Subject: Transmittal of Revision 1 to Service Bulletin No. V2500-ENG-72-0094

To amend part number in the Planning Information sub-paragraph 1.C. (1) (b) and part quantity in the Material Information.

ENGINE - LP COMPRESSOR - REPLACE THE FAN EXIT GUIDE VANE
ASSEMBLY PLATFORM BOLTS

V2500-ENG-72-0094
Page 1 of 9

Location of the FEGV's Platform Special Bolts
Figure 1

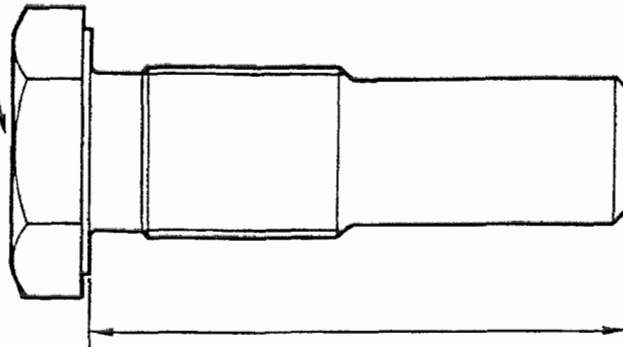
- (a) The existing Special Bolts 5A4122 with change letter "A" have been changed in length from 1.290 - 1.309in. (32,75 - 33,25 mm) to 1.211 - 1.230in. (30,75 - 31,25 mm) and reidentified to a new part number 5A0849. (See Figures 1 and 2).
- (b) The existing 1.211 - 1.230in. (30,75 - 31,25 mm) long Special Bolts 5A4122 with change letter "B" have been reidentified to a new part number 5A0849. (See Figures 1 and 2).

- (1) Install the FEGV's with the forty new 5A0849, Special Bolts, to the LP Compressor/Intermediate Case Module by the approved procedures in the Engine Manual, 72-32-00, Assembly, TASK 72-32-00-430-012. (Refer to 1.K. (2)).

Rework of the FEGV's Platform Special Bolts
Figure 2

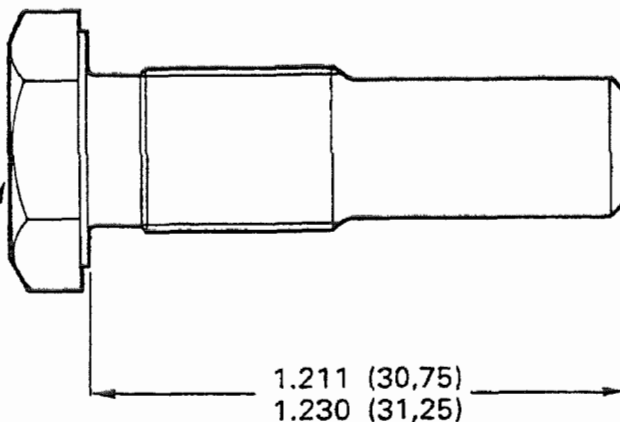
- (2) The existing Special Bolts can be reworked to a new configuration. (See Figure 2).
- (3) New FEGV Platform Special Bolts will be available for future replacement purposes.

- (1) Collect the longer Special Bolts which have the identification number 5A4122A on the bolt head to rework and renumber.
- (2) Collect the shorter Special Bolts which have the identification number 5A4122B on the bolt head to renumber.
- (3) Rework the identification number 5A4122A, longer Special Bolts, with the identification No. RM007, Standard Precision Lathe, to decrease the length of Bolts. (Refer to Figure 2 and 1.K. (3)).

MARK NEW PN 5A0849 WITH VIBRO-PEEN ADJACENT TO EXISTING PN 5A4122A IDENTIFIED HERE. MARK TWO LINES (≡) ON EXISTING PN WITH VIBRO-PEEN TO ERASE IT.

BEFORE ALTERATION 1.290 (32,75)
1.309 (33,25)

AFTER ALTERATION 1.211 (30,75)
1.230 (31,25)

CHAMFER
0.031 (0,8) x 45 DEG

MACHINE WHERE MARKED ✓ TO DECREASE THE LENGTH OF PN 5A4122A BOLT.
SURFACE TEXTURE TO BE 248 MICROINCHES (6,3 MICROMETERS).
BREAK SHARP EDGES 0.003-0.015 (0,08-0,38).

MARK NEW PN 5A0849 WITH VIBRO-PEEN ADJACENT TO EXISTING PN 5A4122B IDENTIFIED HERE. MARK TWO LINES (≡) ON EXISTING PN WITH VIBRO-PEEN TO ERASE IT.
